INITIAL FIRE SAFETY INSPECTION REPORT

Mazib Fashions Ltd.

RSC ID: 24077

Date: 09-September-2024

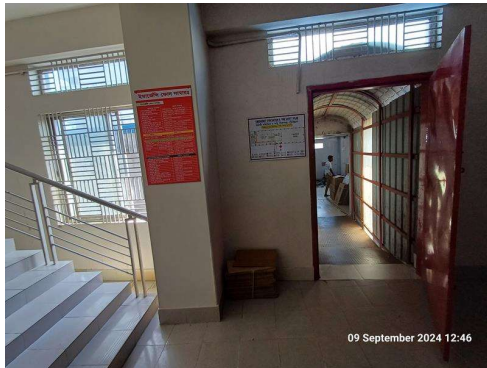
SI No.	Category	Findings	Required Action	Remediation Time Frame
F-01	Fire rated Construction	Areas used for combustible storage are open to the factory floor area and are not separated by fire rated construction. Location: 5th floor of Building-1	Provide dedicated storage rooms separated by a minimum 1-hr fire-rated construction. Provide minimum 0.75 hr. fire rated doors and seal all penetrations and openings by 1 hr. fire rated barrier construction. Where separate storage rooms are not feasible, provide defined storage areas and limit the storage arrangement as follows: - - Maximum height of 2.45m (8ft.) , maximum area of 23m2 (250 ft2) and 3m (10ft.) clear distance from adjacent another unenclosed combustible storage. - If the building/floor is sprinkler protected: maximum height of 3.66m (12ft.) and maximum area of 93m2 (1000 ft2) and and 3m (10ft.) clear distance from adjacent another unenclosed combustible storage.	Within 1 month
